METRO FLOOD DIVERSION AUTHORITY

<i>Construction Change Orders</i>		
WP-42A.1/A.3, 4th Street Pump Station Change Order 09 <ul style="list-style-type: none">Fuel level Sensors, Floodwall coping, and Trash Rack Modifications	ICS, Inc.	\$12,506.80
Total Construction Change Orders		\$12,506.80

WP-42A.1/A.3

4th Street Pump Station and Gatewell - 2nd Street Floodwall South

Series HTF Standard Three Float Sensor

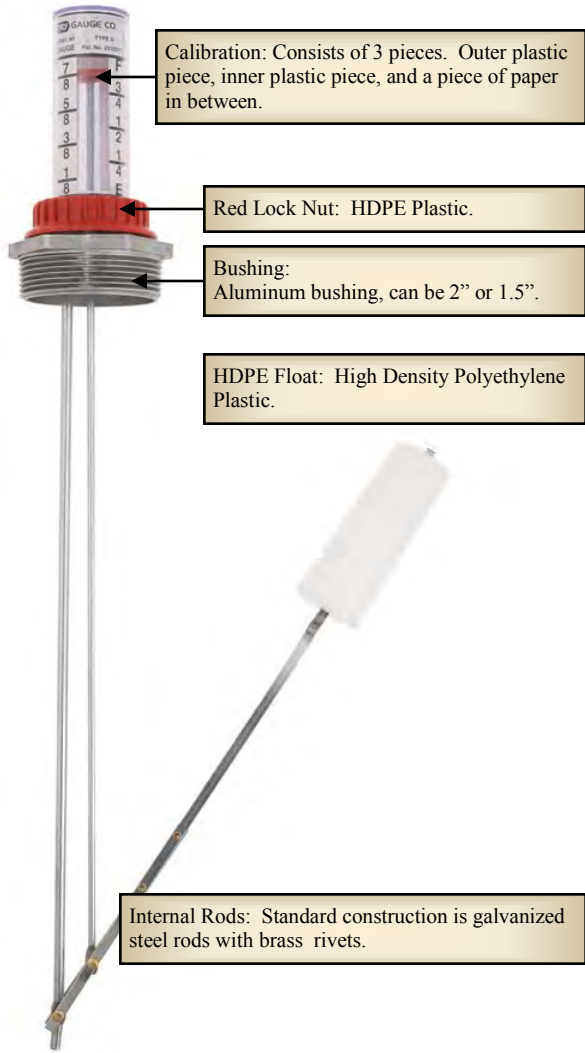
The attached costs are to add level sensors to the fuel storage tank. The added sensors will monitor the 25%, 50% and 75% fuel levels in the fuel tank.

The level sensors will be added per the attached quote from Fusion Automation OPTION A. The proposed sensor information is also attached to this quote.

OPTION A: HTF 3 float stem sensor

Task: Trash Rack Adjustment

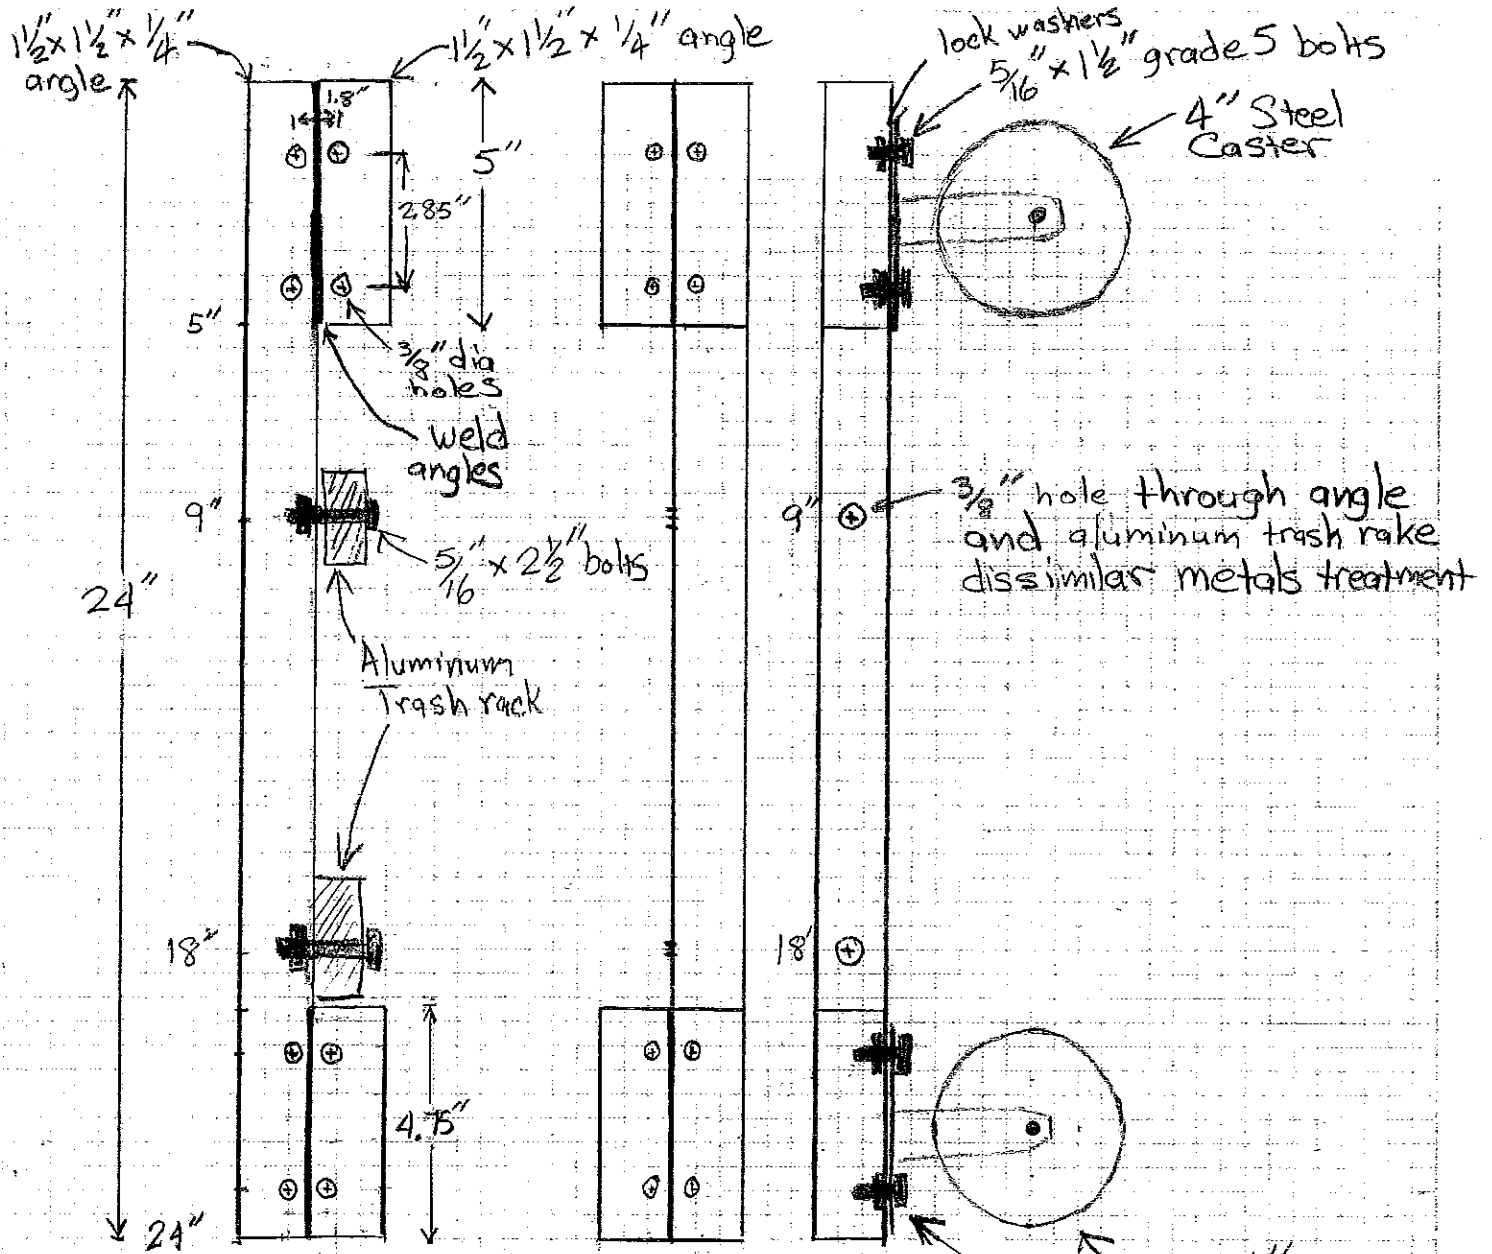
- Trash Rack Modifications.** The installed trash racks do not operate smoothly and jam frequently during operation. The Engineer, with assistance from the Contractor, has researched and developed a solution that includes fabricating and installing additional guide rollers on each of the trash racks. This change adds \$6,393.00 to the Contract Price to fabricate, install, and test the guide rollers. The Owner’s Representative and Engineer have reviewed this cost and found it to be reasonable.

The attached cost is for a design change to the Trash Rack Rake System in the pump station. Glen Krogman with HMG requested the change so that the trash racks would operate smoother.

The trash rack rake modifications were requested by HMG to improve functionality. Glen Krogman with HMG provided a sketch dated 12-07-16 showing the changes and is the basis for our pricing. It is our understanding that the design was based on a prototype that operated in the field. This price includes materials, labor for installation, as well as labor to help Glen in the field with fitting his prototypes.
